VENDOR SERVICE PUBLICATION

SUBJECT: Oil Pump Impeller and Drive Replacement; AVCO Lycoming Service Bulletin No. 385C dated October 3, 1975 (attached).

Service Bulletin No. 385C
(Supersedes Service Bulletin No. 385B)
Engineering Aspects are
FAA (DEER) Approved

SUBJECT: Oil Pump Impeller and Drive Replacement

Figure 1. Interior View of Accessory Housing Showing Location of Cotter Pin in Oil Pump Idler Shaft

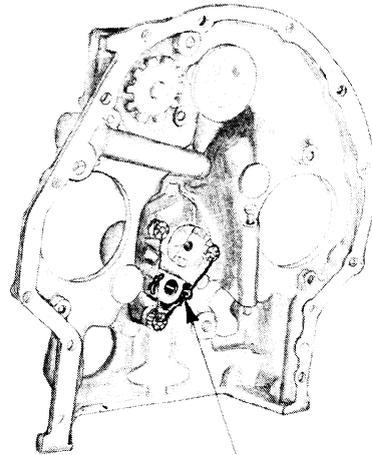
INSPECTION: Applicable remanufactured engines shipped after December 21, 1972 should be inspected to determine if this modification is required: first of all, if the engine log book indicates the engine has not been modified in accordance with Service Instruction No. 1230 or No. 1272, proceed to remove the accessory drive cover from the mounting pad at the lower right side of the accessory housing to obtain access to the area between the crankcase and the accessory housing. On some engines this accessory drive pad is not machined, in this event it will be necessary to remove either the left magneto or the *fuel pump to obtain access to the area between the crankcase and the accessory housing. Regardless of which accessory pad is used, determine if the oil pump idler gear is secured with a cotter pin at the location shown in figure 1. This can be accomplished using an inspection mirror, preferably an illuminated one. If the cotter pin is visible, it is unnecessary to perform the modification required by this bulletin.

IF IDLER SHAFT IS SECURED WITH A COTTER PIN AT THIS LOCATION MODIFICATION IS NOT REQUIRED

Figure 2. Oil Pump Drive Assembly

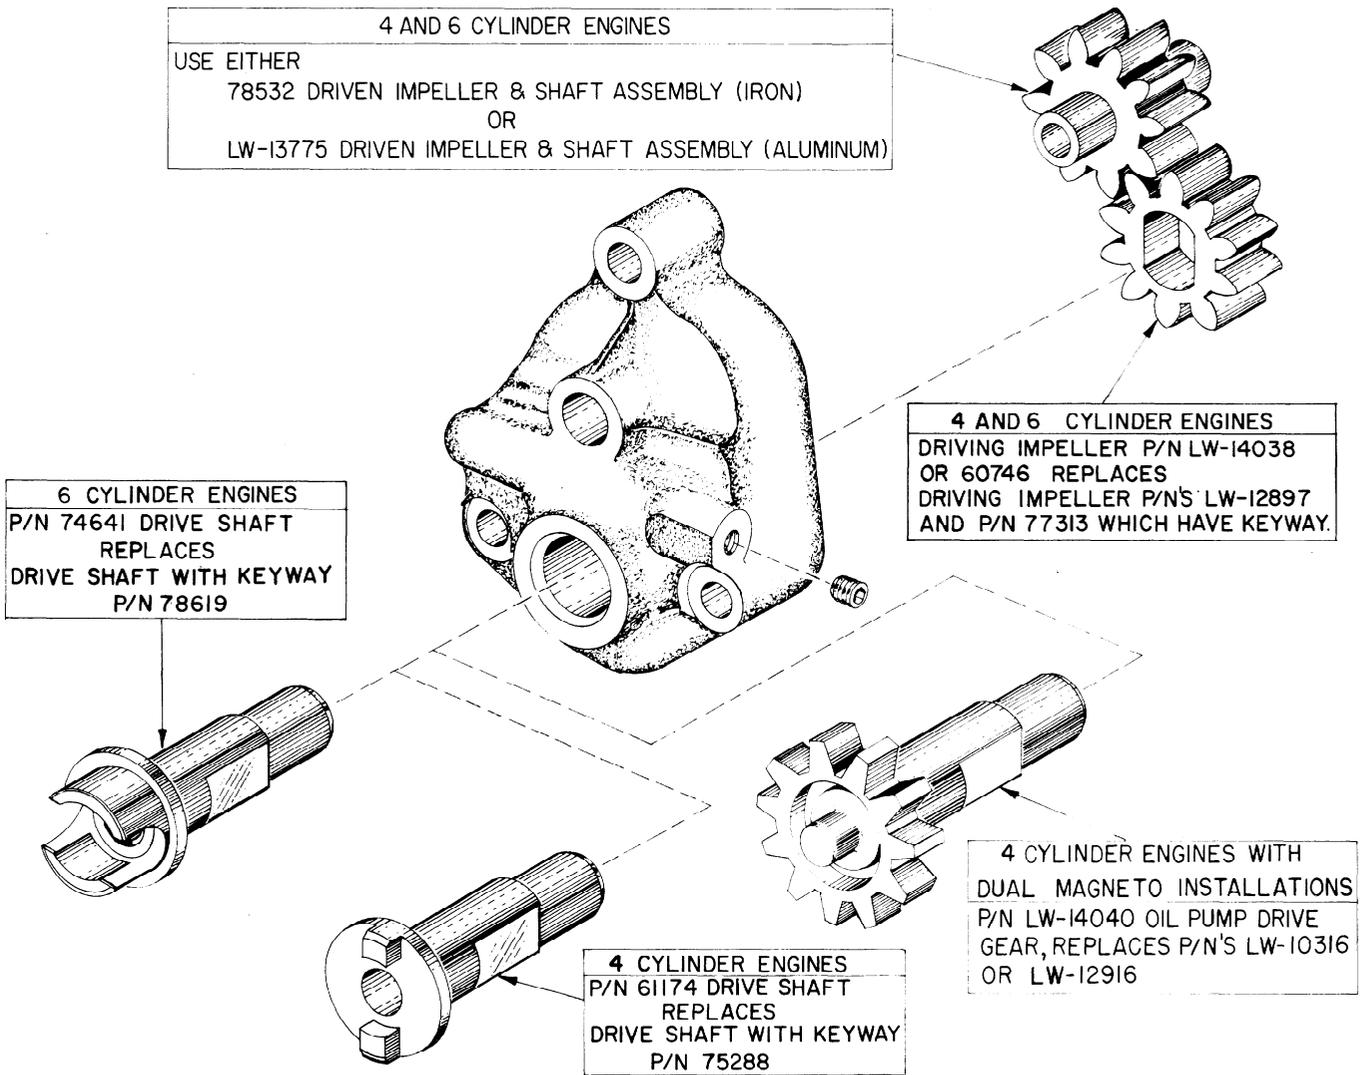
This modification consists of replacing the oil pump drive shaft and drive impeller to eliminate the Woodruff key drive which has proven to be the cause of excessive wear in the keyway of the hardened drive impeller. Therefore, it is recommended that all of the applicable engines listed in the chart, as well as any others that may have been modified in accordance with Service Instruction No. 1272, use the following procedure for parts replacement.

3. Reassemble the oil pump using the new drive shaft and drive impeller supplied with the kits shown in the following "Parts Data" section. See figure 2. Be sure all of the parts are lubricated thoroughly during assembly.

- LW-14131 Oil Pump Shaft Replacement Kit (4 cylinder engines)
consists of: (1) 61174 oil pump drive shaft, (1) LW-14038 or 60746 drive impeller

- LW-14132 Oil Pump Shaft Replacement Kit (4 cylinder, dual drive magneto engines)
consists of: (1) LW-14040 oil pump drive gear, (1) LW-14038 or 60746 drive impeller

- LW-14133 Oil Pump Shaft Replacement Kit (6 cylinder engines)
consists of: (1) 74641 oil pump drive shaft, (1) LW-14038 or 60746 drive impeller
